DONCASTER BEVERLY DANBURY RECONSTRUCTION

ASSESSMENT DISTRICT - 2024

CITY PROJECT NO. 14079
CONTRACT NO. 8709

REVISION #1- 8/15/2024
REVISED THE FOLLOWING:
EC4, EC6, G11, G13-G15, PD2-PD6, P2-P6, U4-U5, W1, X4-X5, X7, X9, X12

14079
PD-2

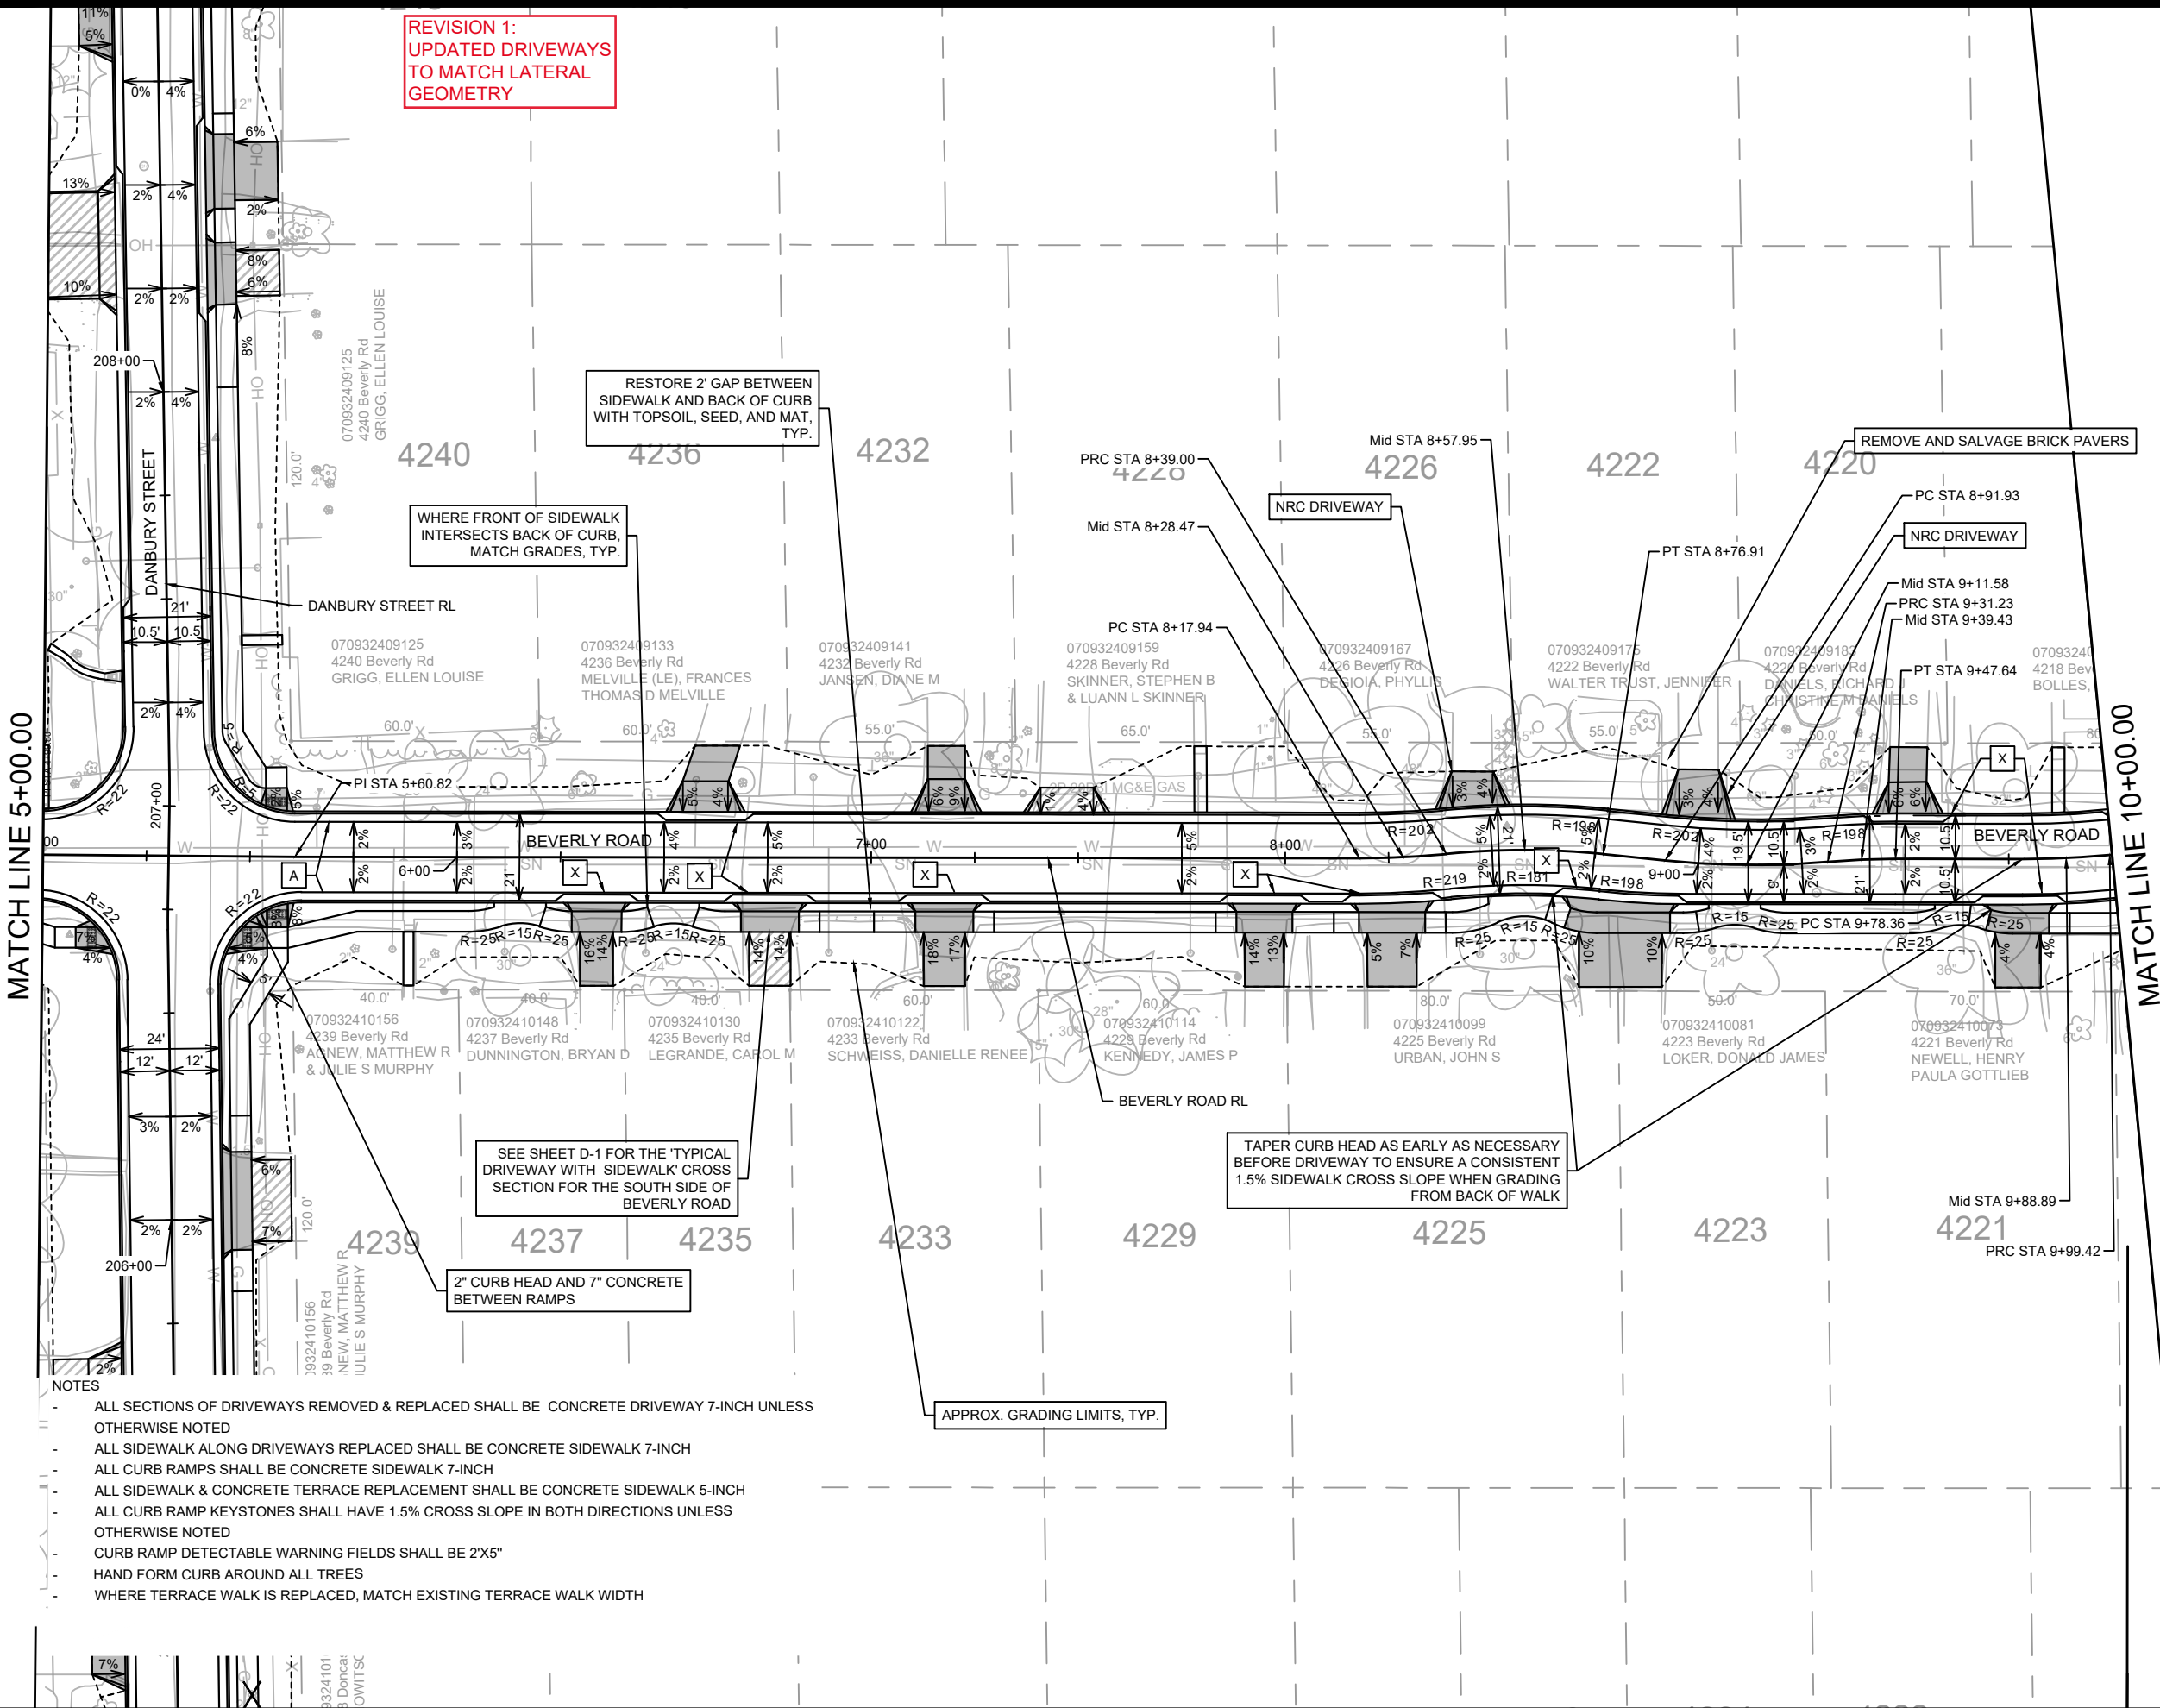
**REVISION 1:
UPDATED DRIVEWAYS
TO MATCH LATERAL
GEOMETRY**

14079
PD-3

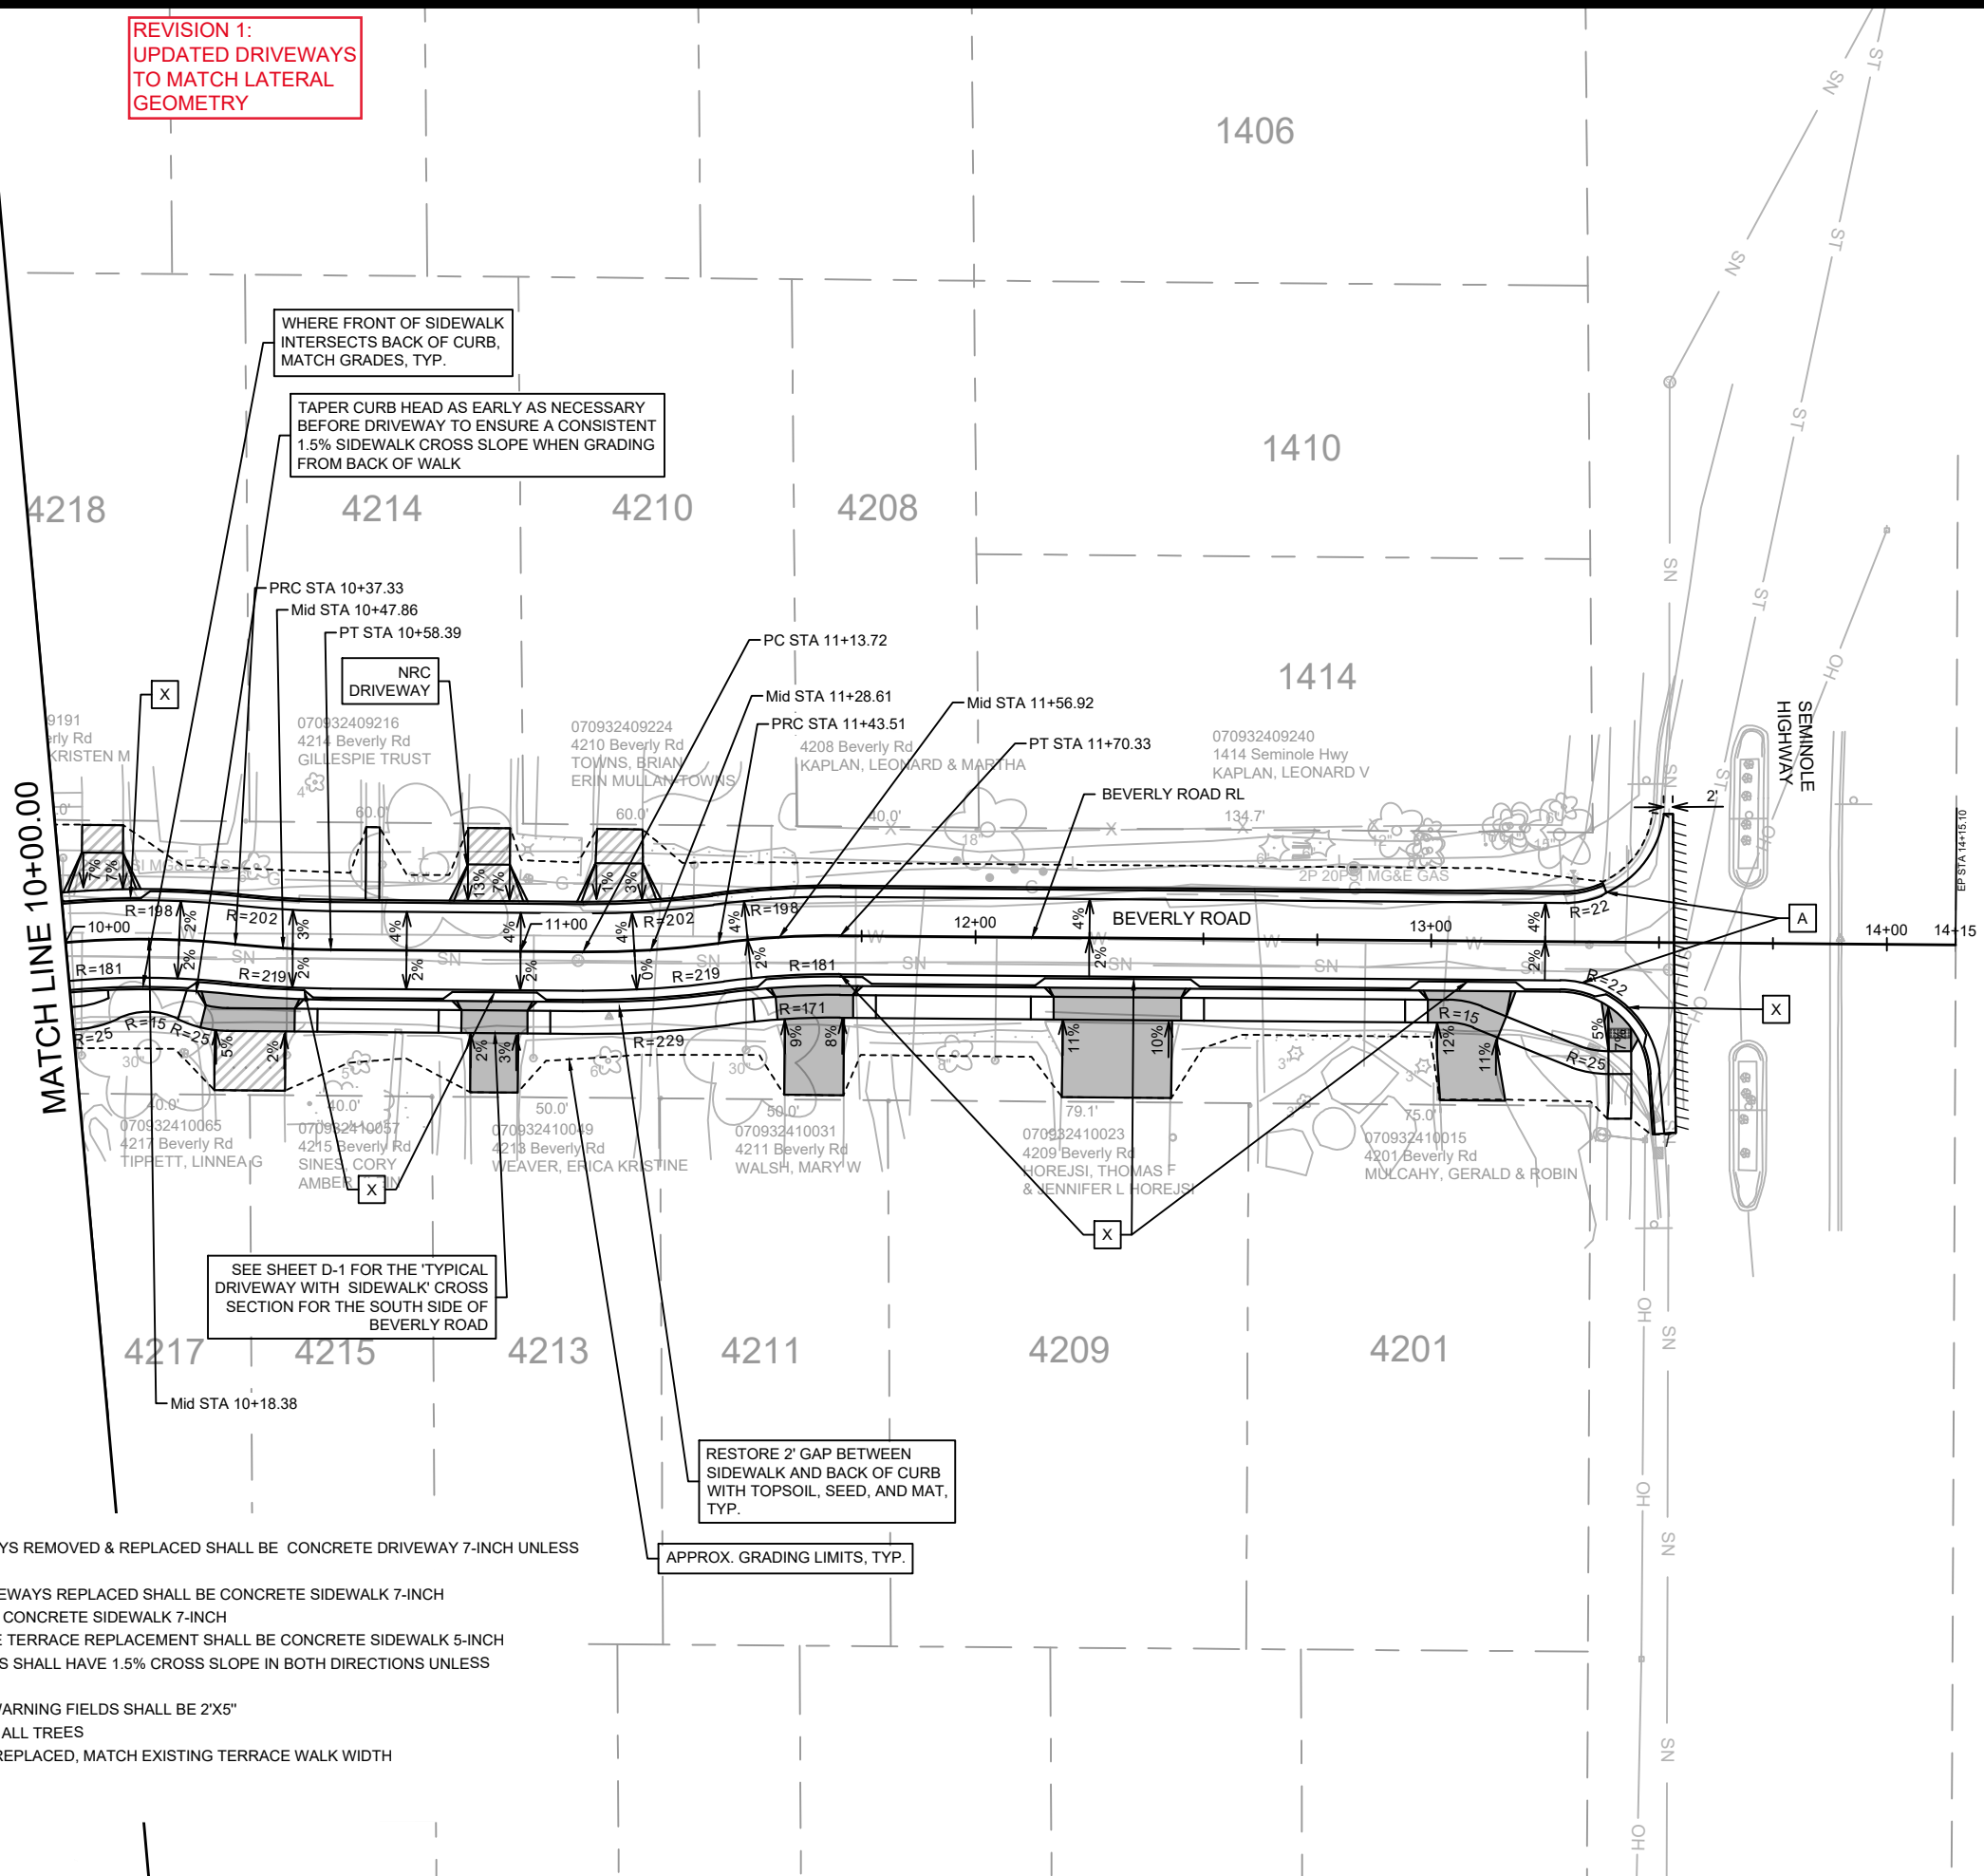
REVISION 1:
UPDATED DRIVEWAYS
TO MATCH LATERAL
GEOMETRY

14079
PD-4

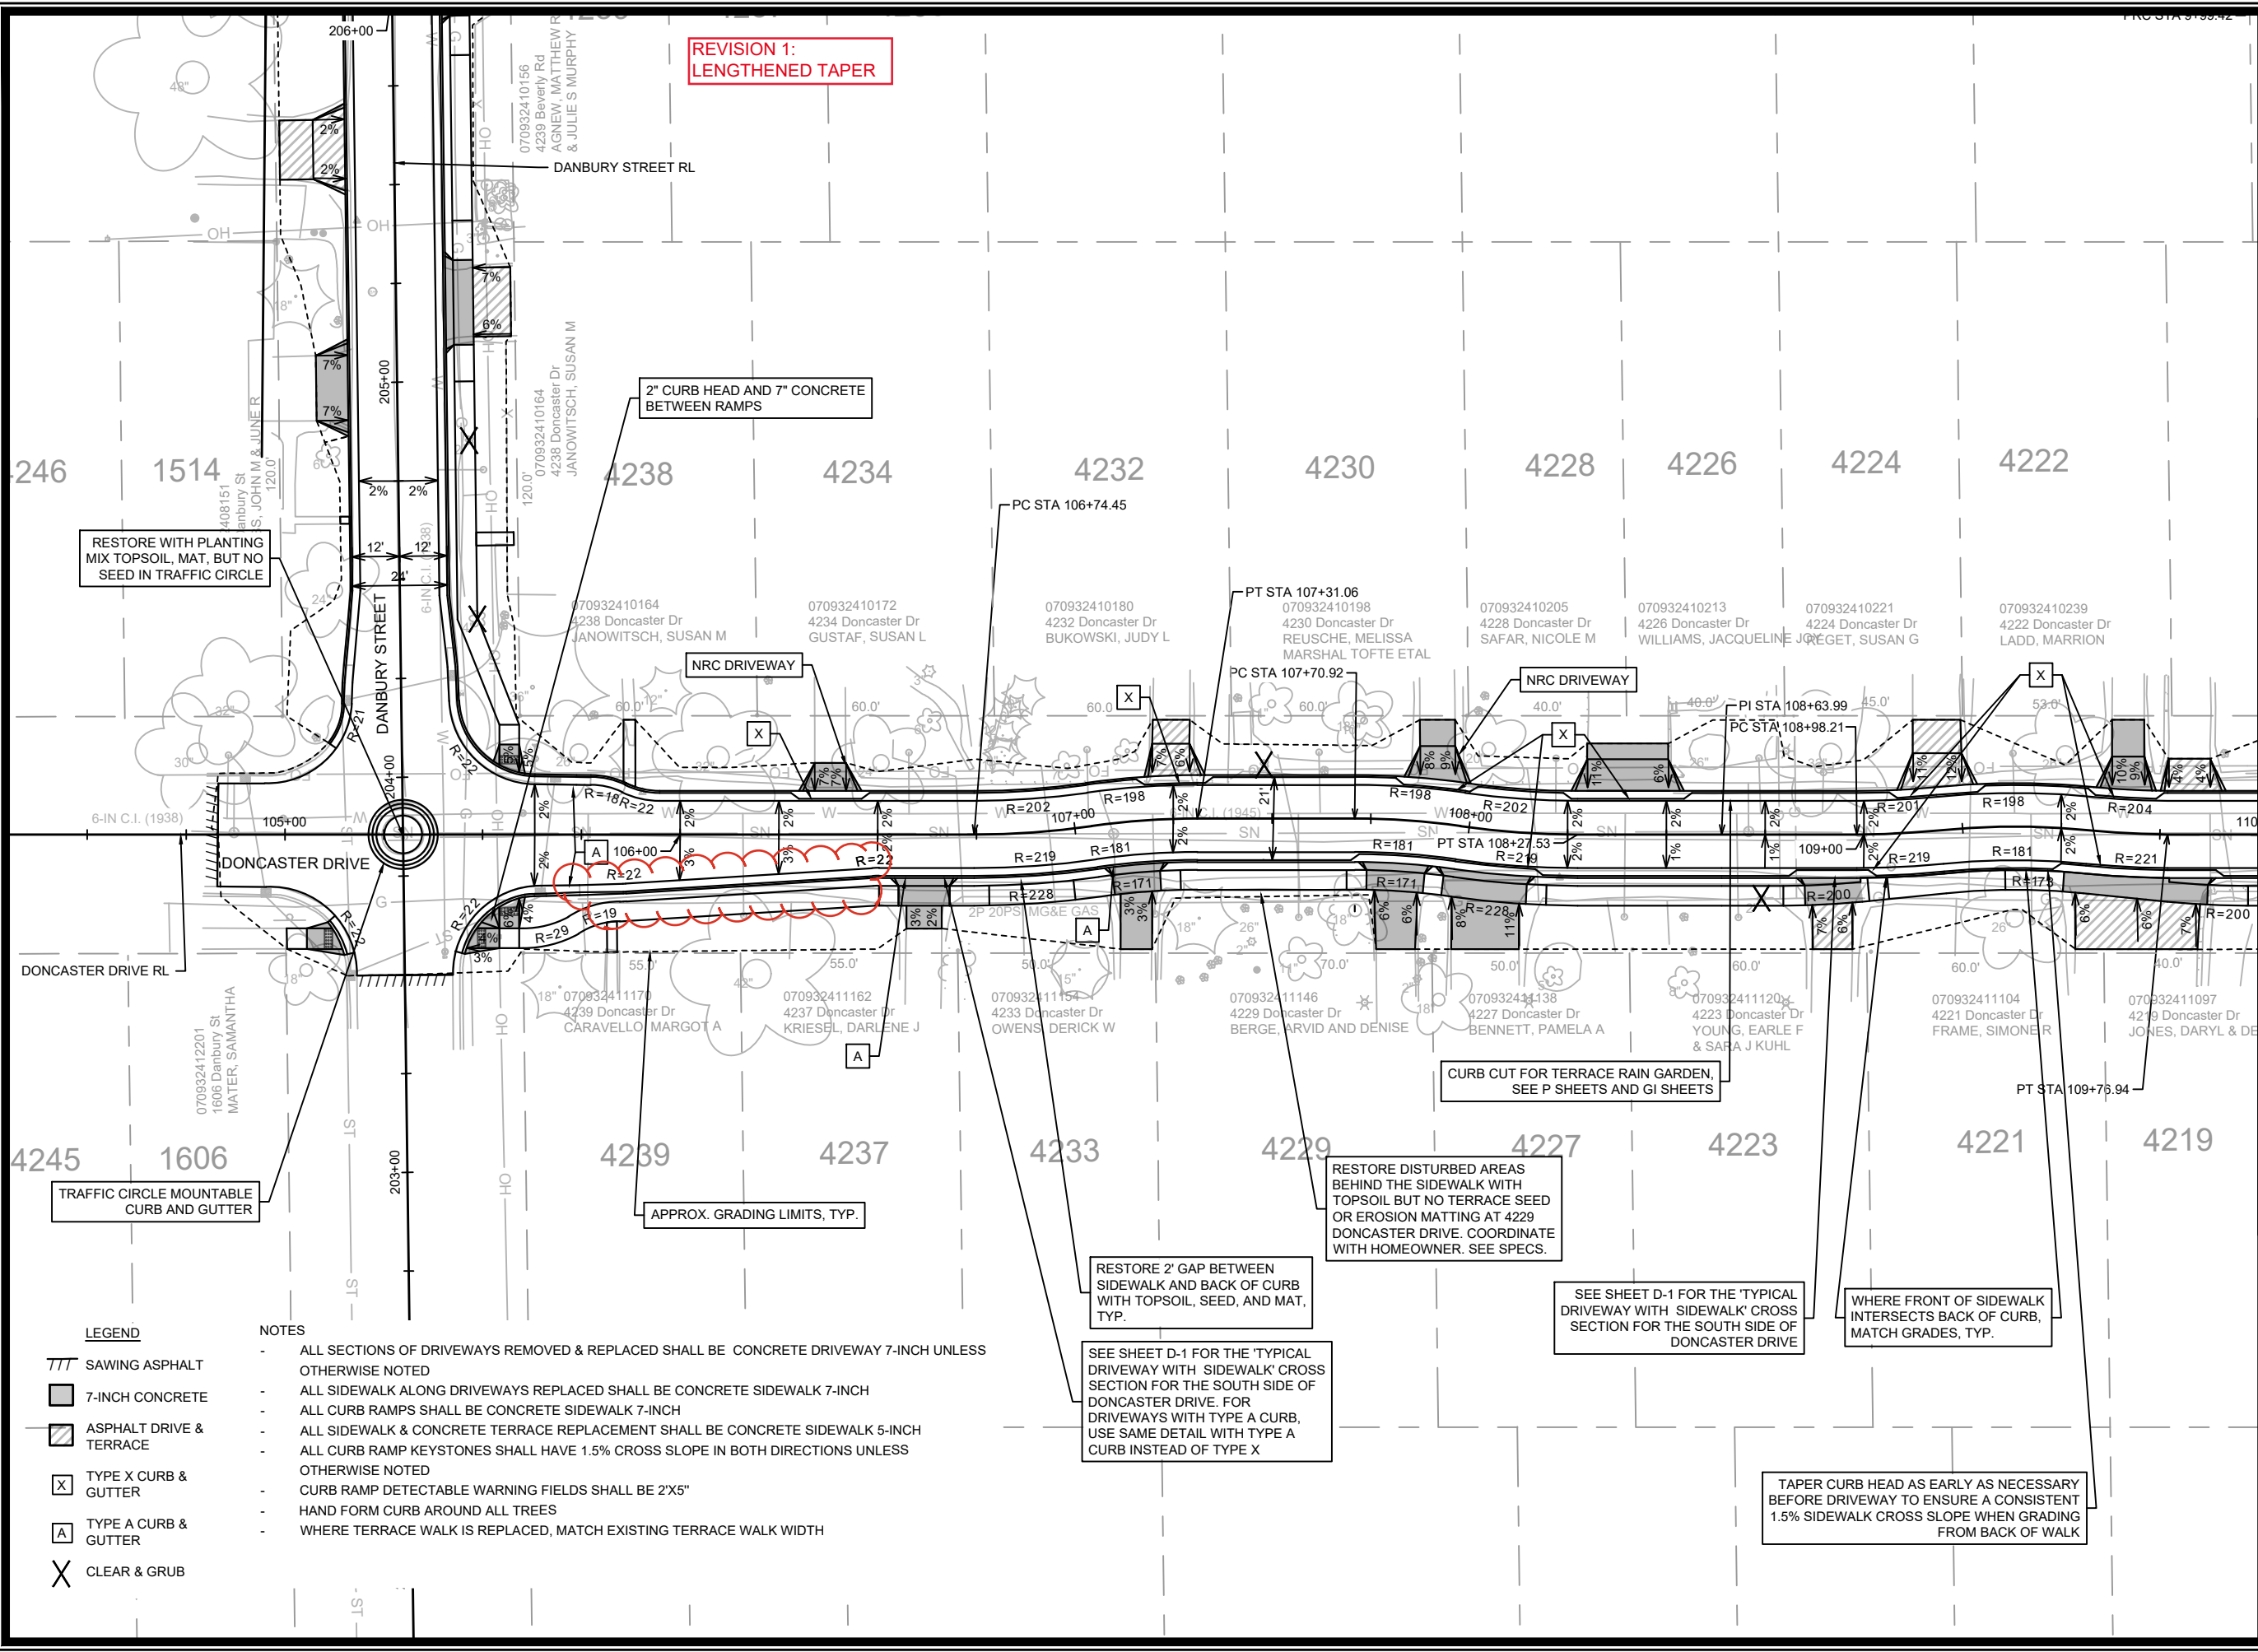
REVISION 1:
LENGTHENED TAPER
